The City of Spartanburg Design Review Board

AGENDA

August 5, 2025, at 5:30 P.M.

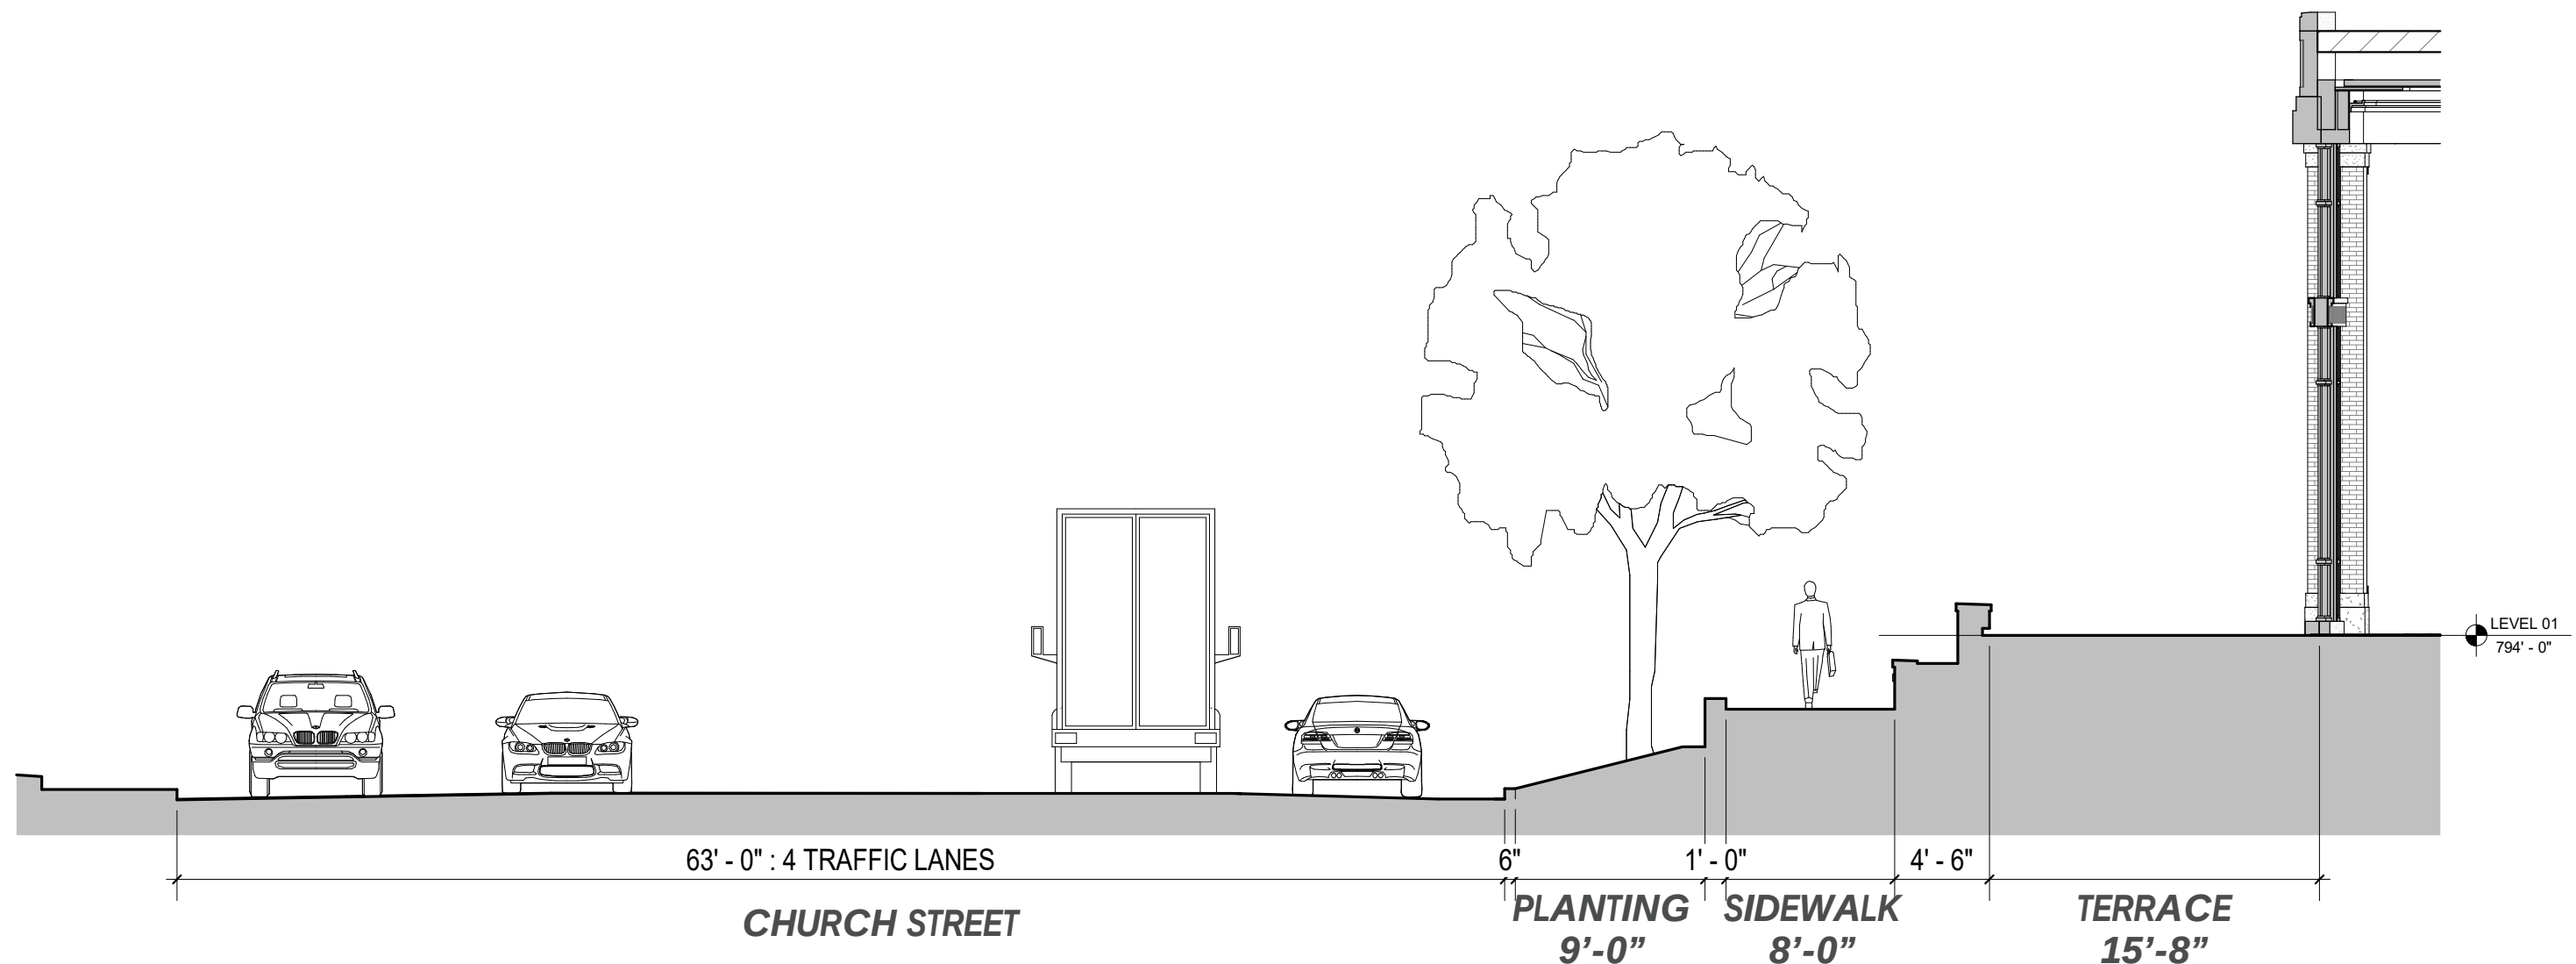
52 LINEAR FT OF GLAZING = 39% OF FRONTAGE

**VARIANCE GRANTED DURING
PRELIMINARY REVIEW**

FLOOR PLAN - LEVEL 1
1/32" = 1'-0"

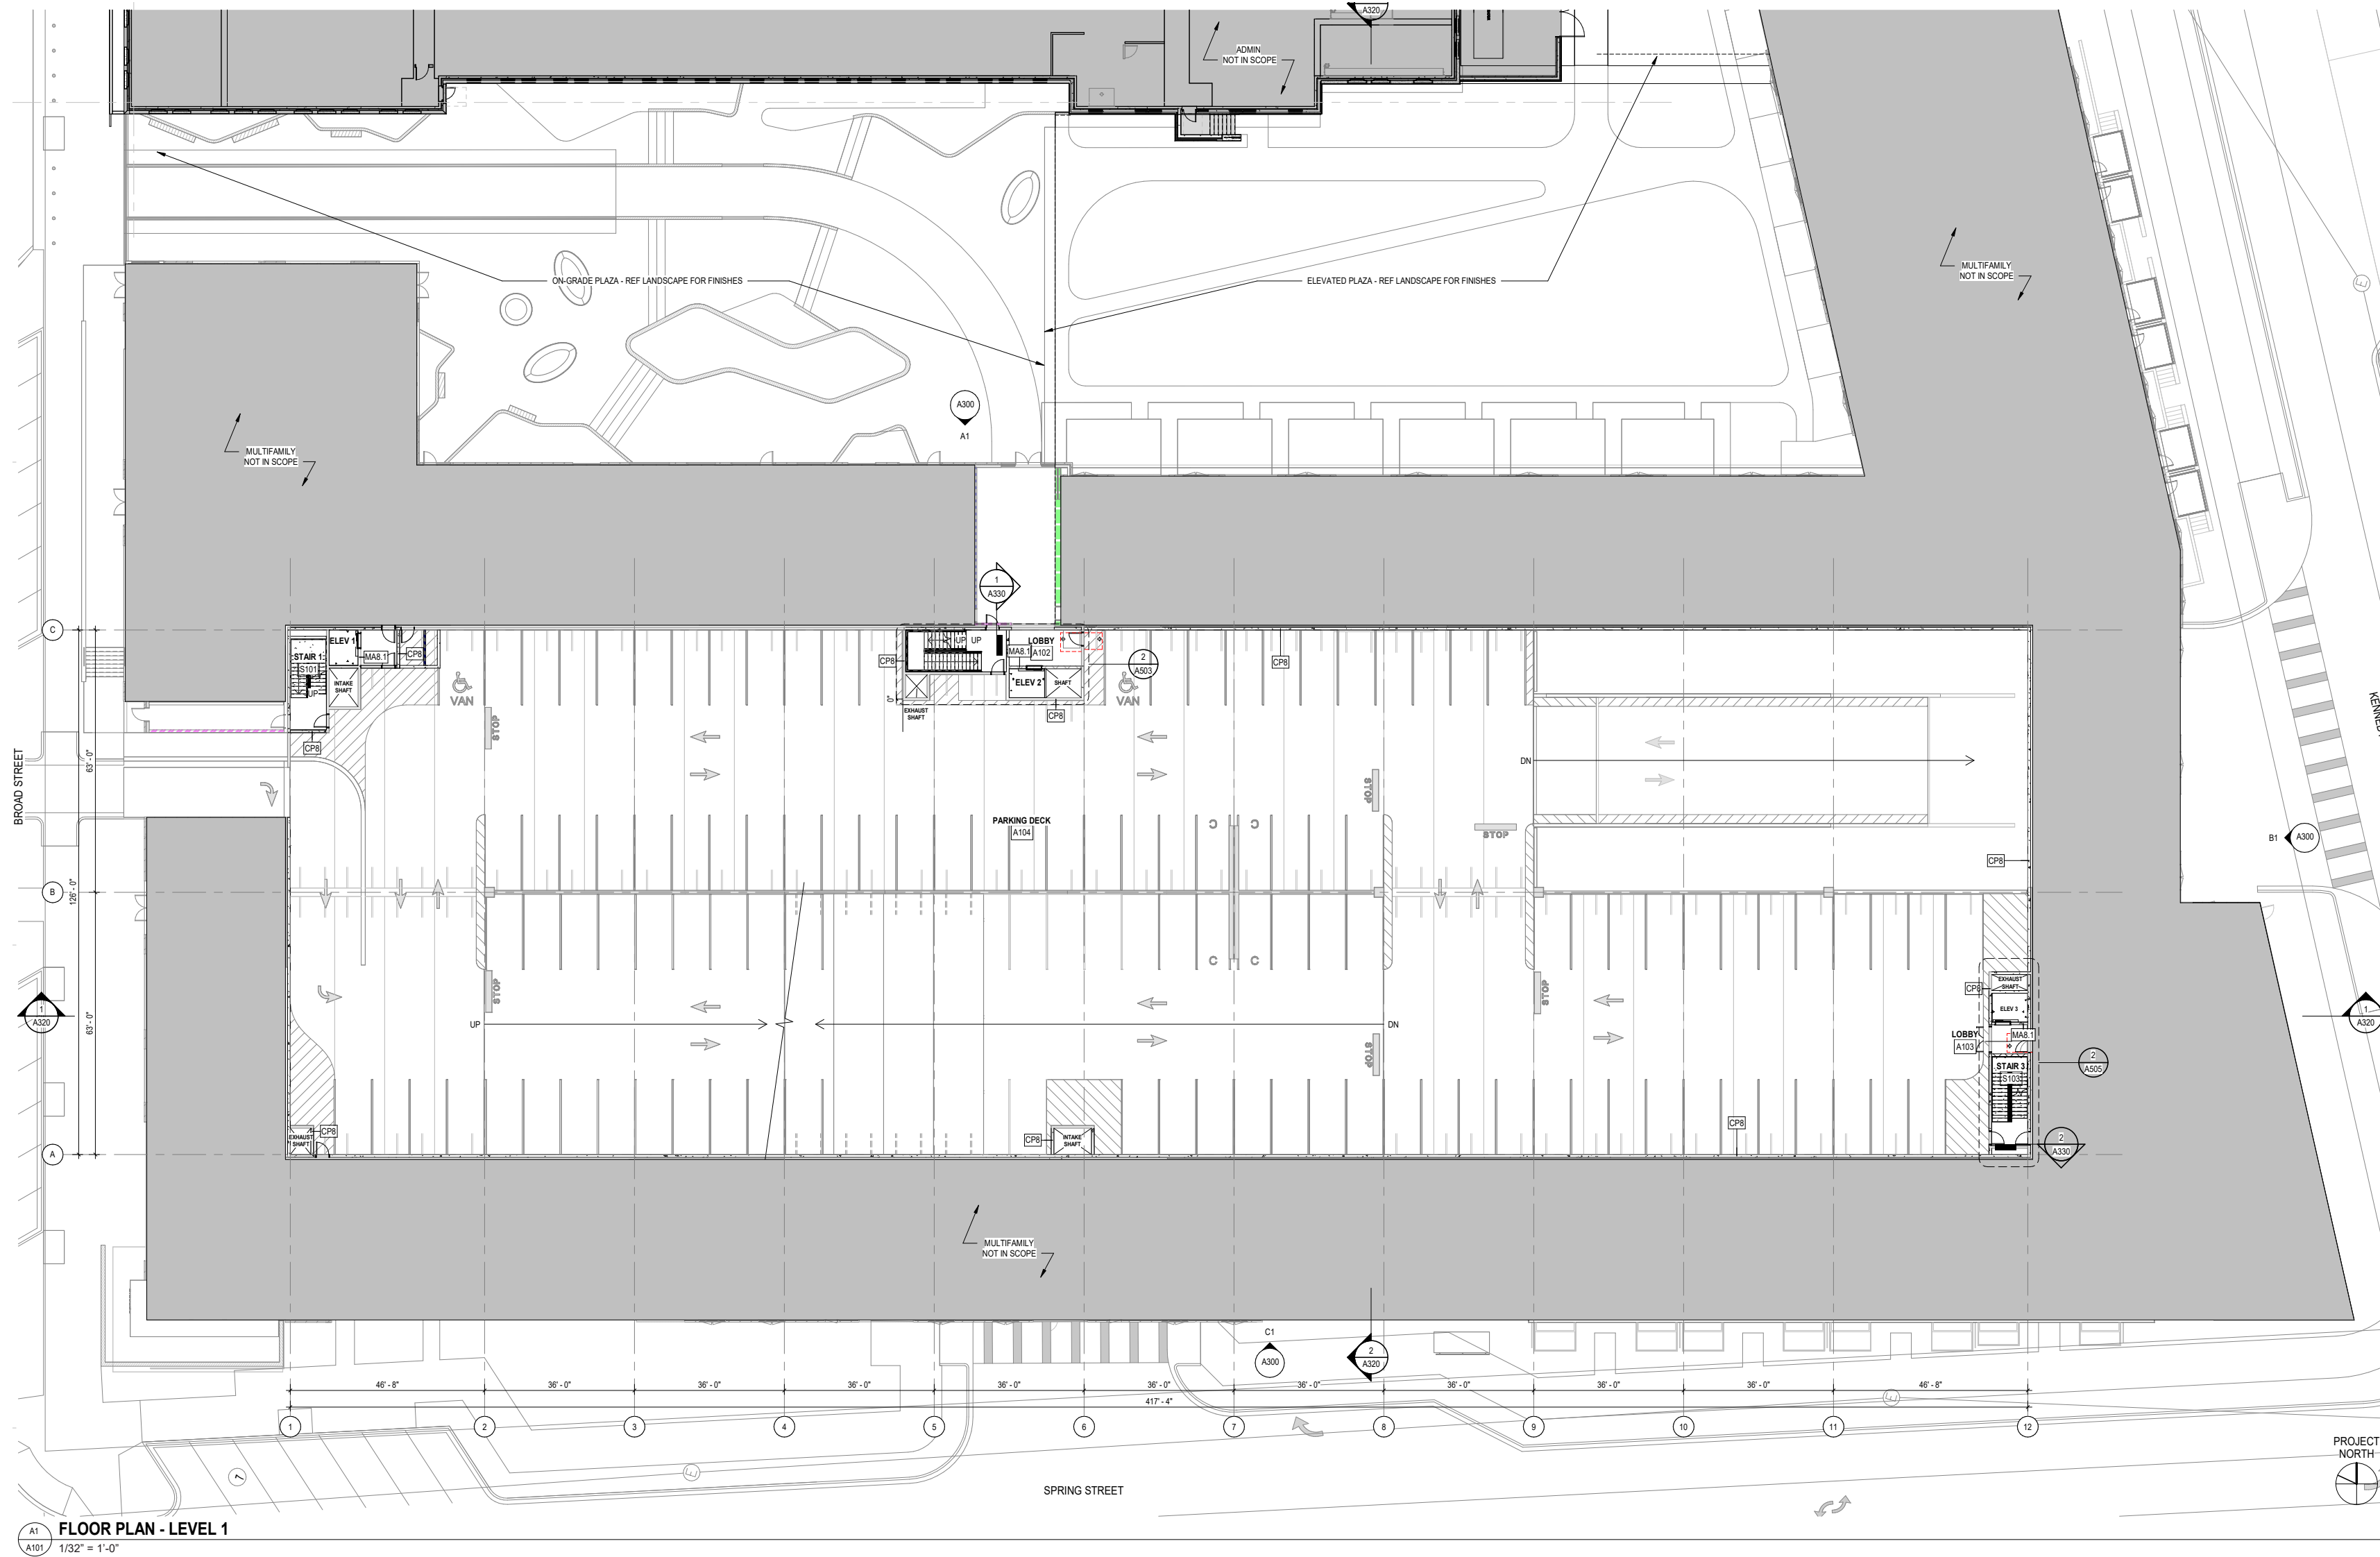
Requested Modification: Permit a vehicular entrance width of 68 feet at the Kennedy St. entrance to the structure.

LOCATION OF
REQUESTED DESIGN
STANDARD
MODIFICATION

UNIT 5
ELEVATION A

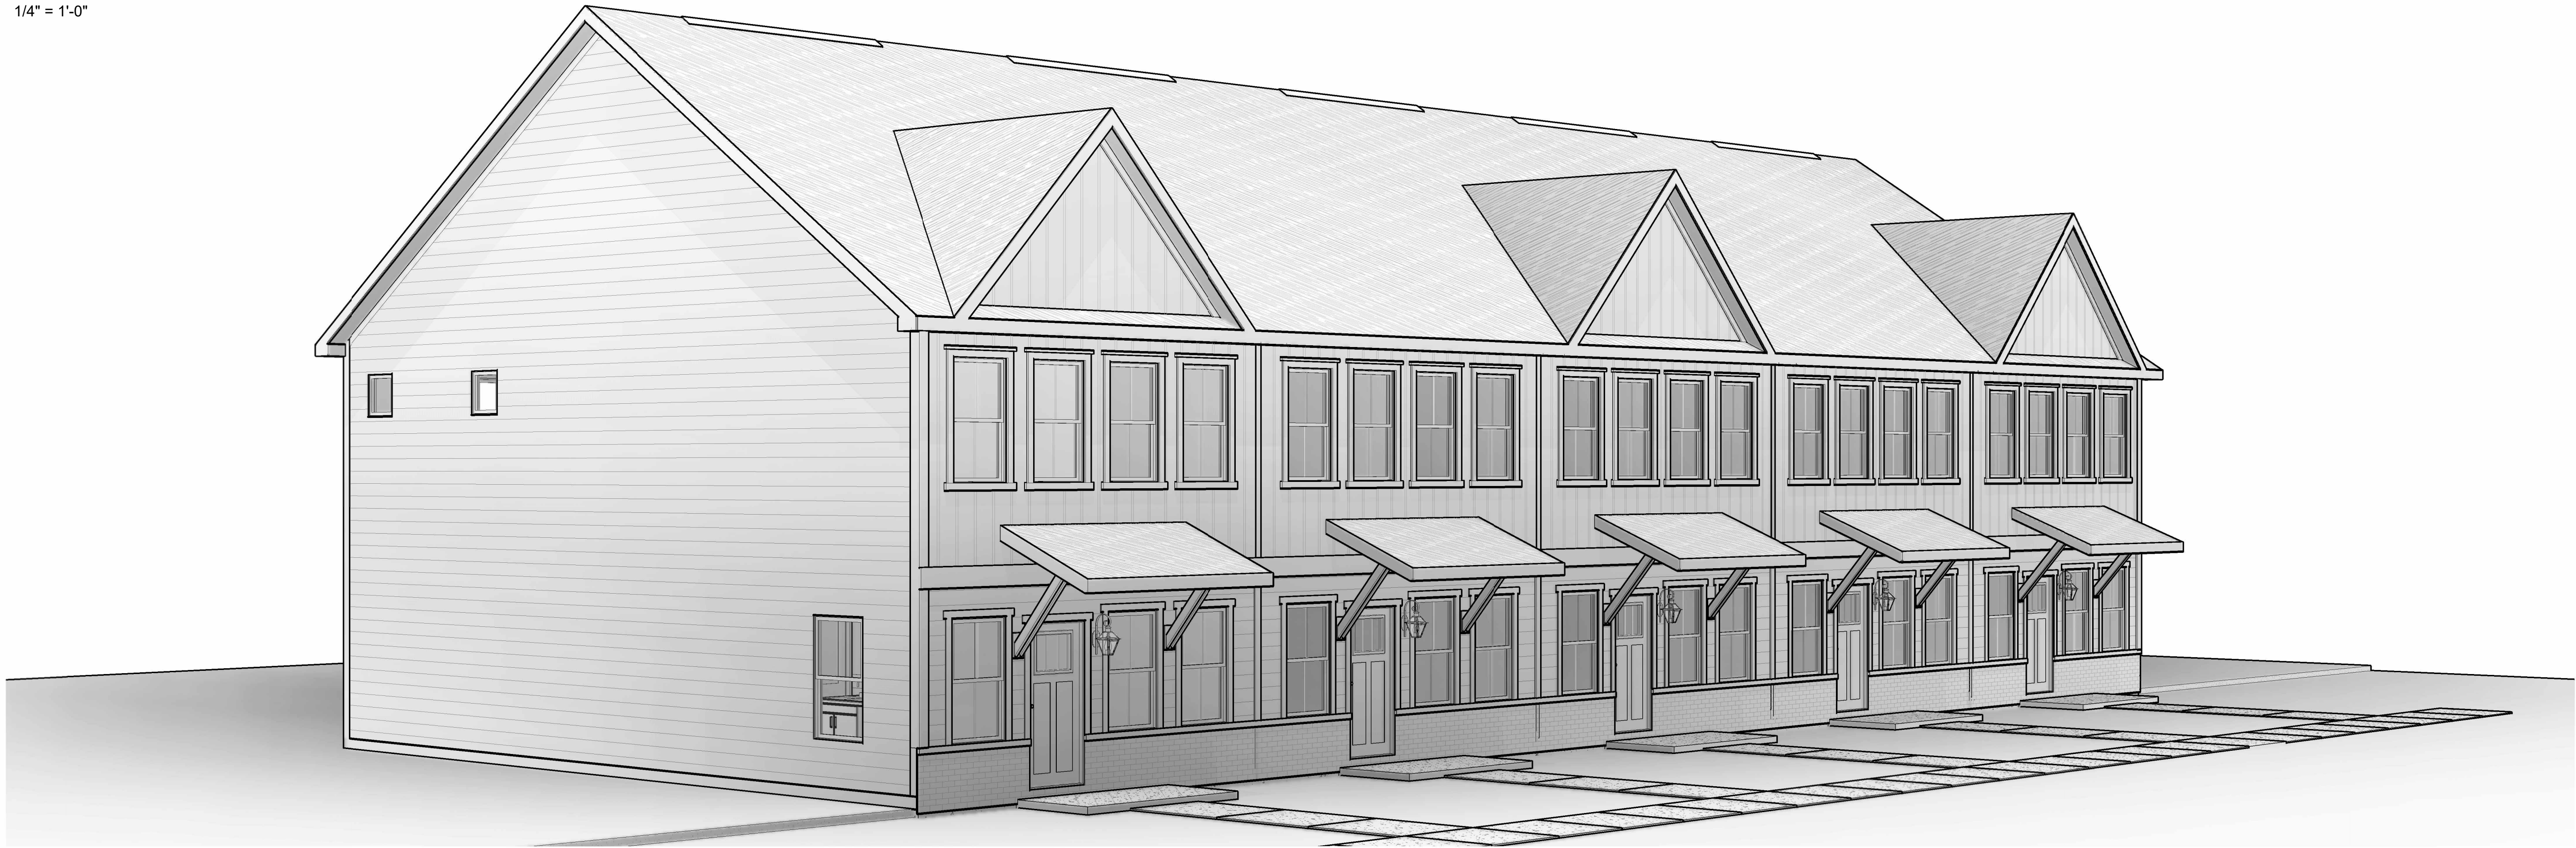
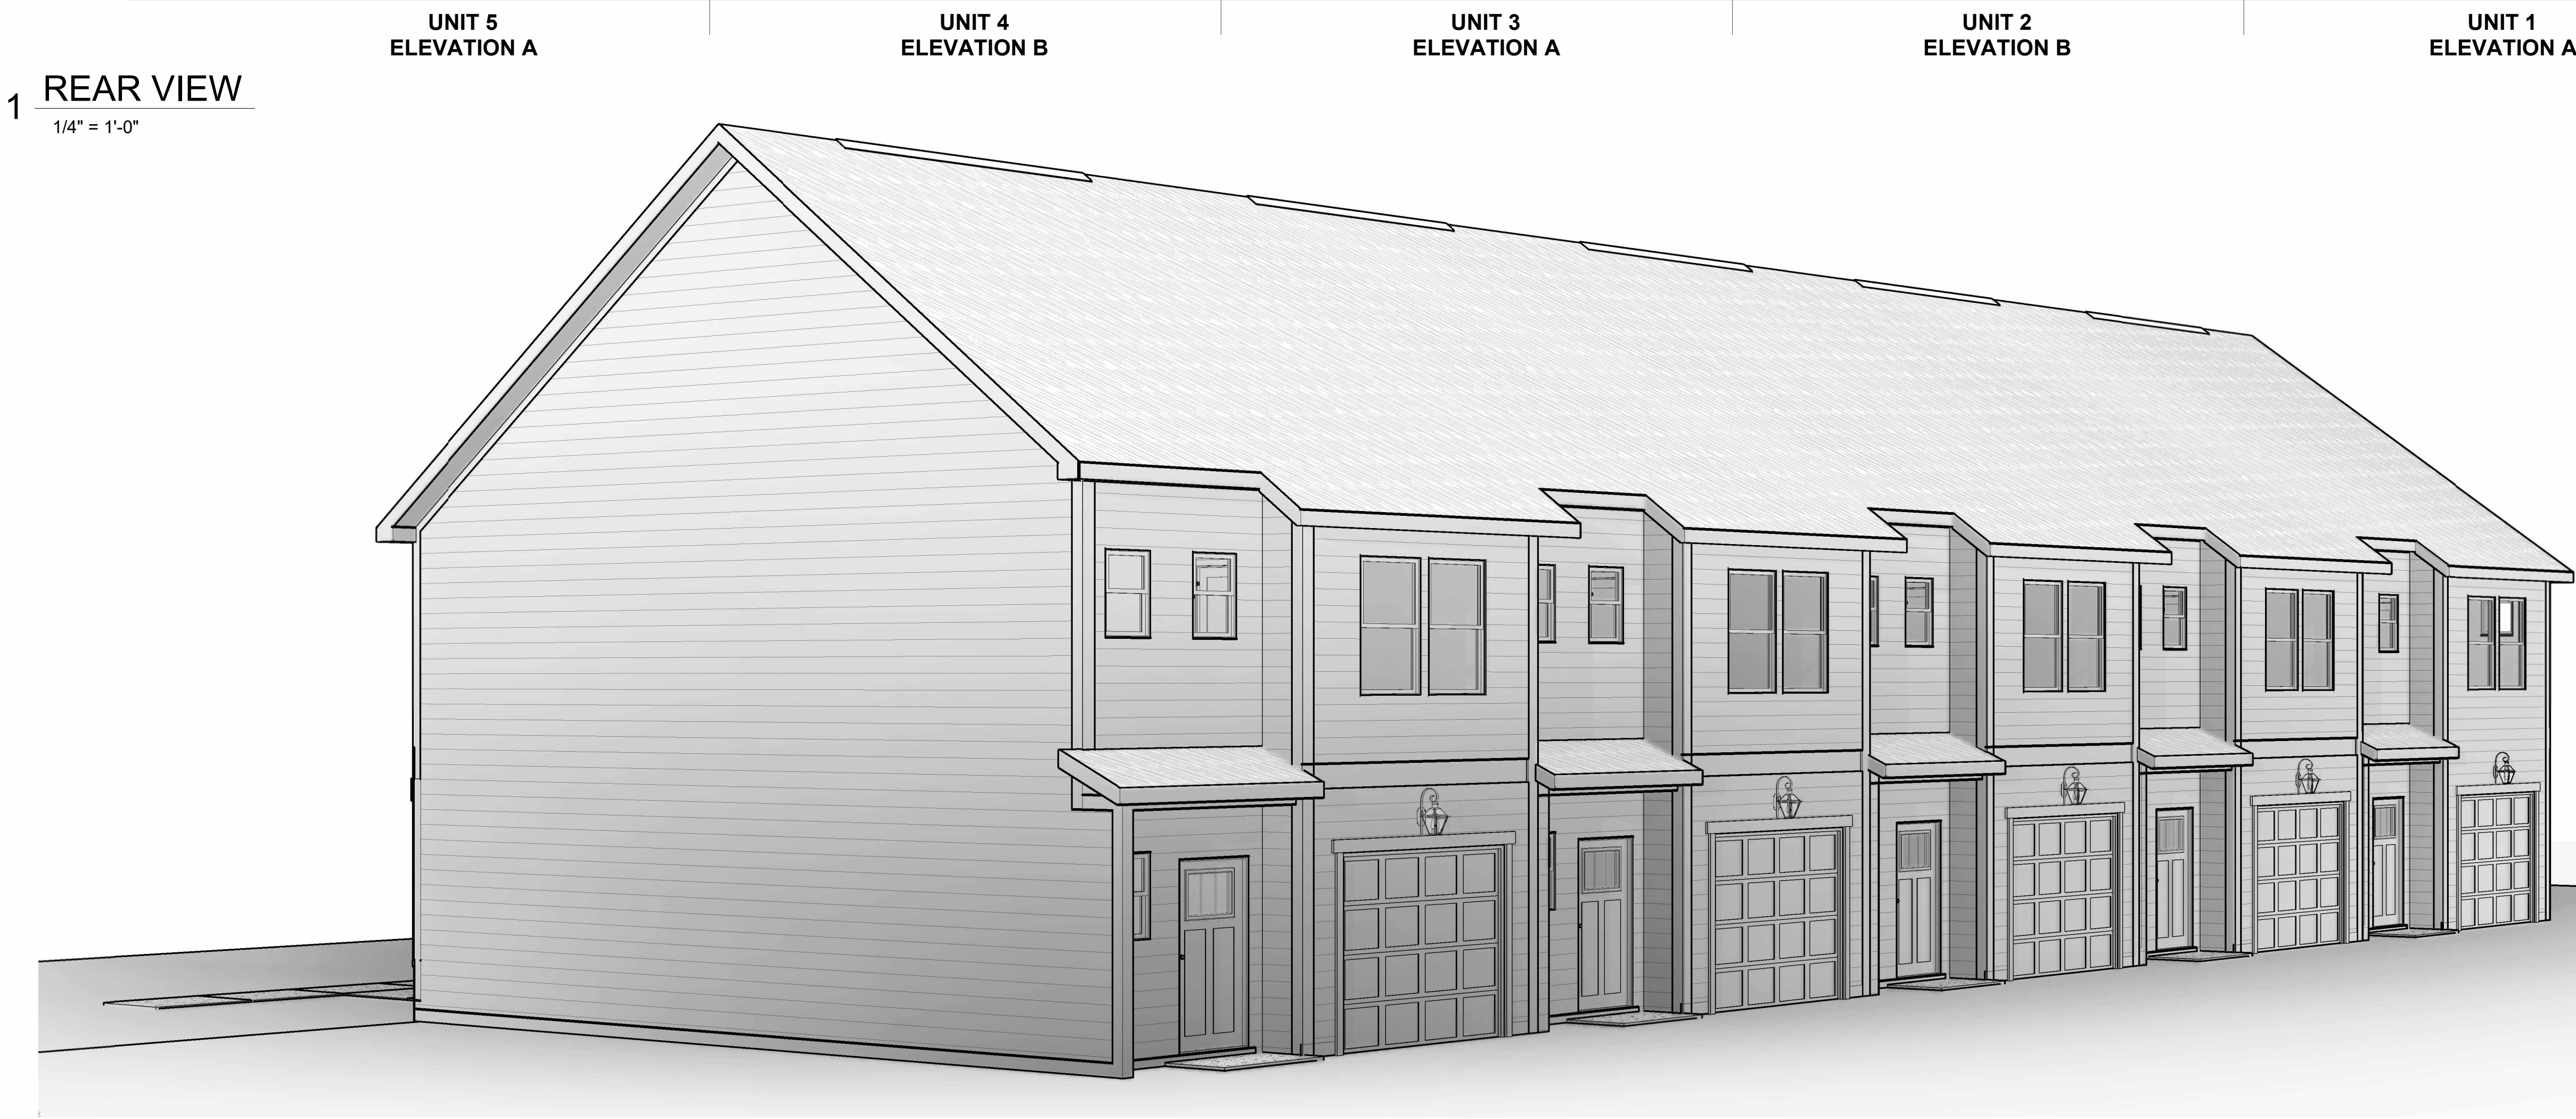
- 6.3.1 Roof and Eaves: *Compliant.*
 - 6.3.2 Façade Design: *Compliance Presumed – to be confirmed prior for Final Approval*
 - 6.3.3 Building Entrances: *Entrances do not appear to be raised a minimum of 2 feet from the finished grade. A porch or stoop does not appear to be the predominate design element for the entrance. Plans note slab on grade foundation.*

Building Design: The submitted plans indicate raised entries, however there are no elevations to substantiate the design. Confirmation is required. There is no reason to vary this standard as recent approvals including below-market rate projects have met this standard.
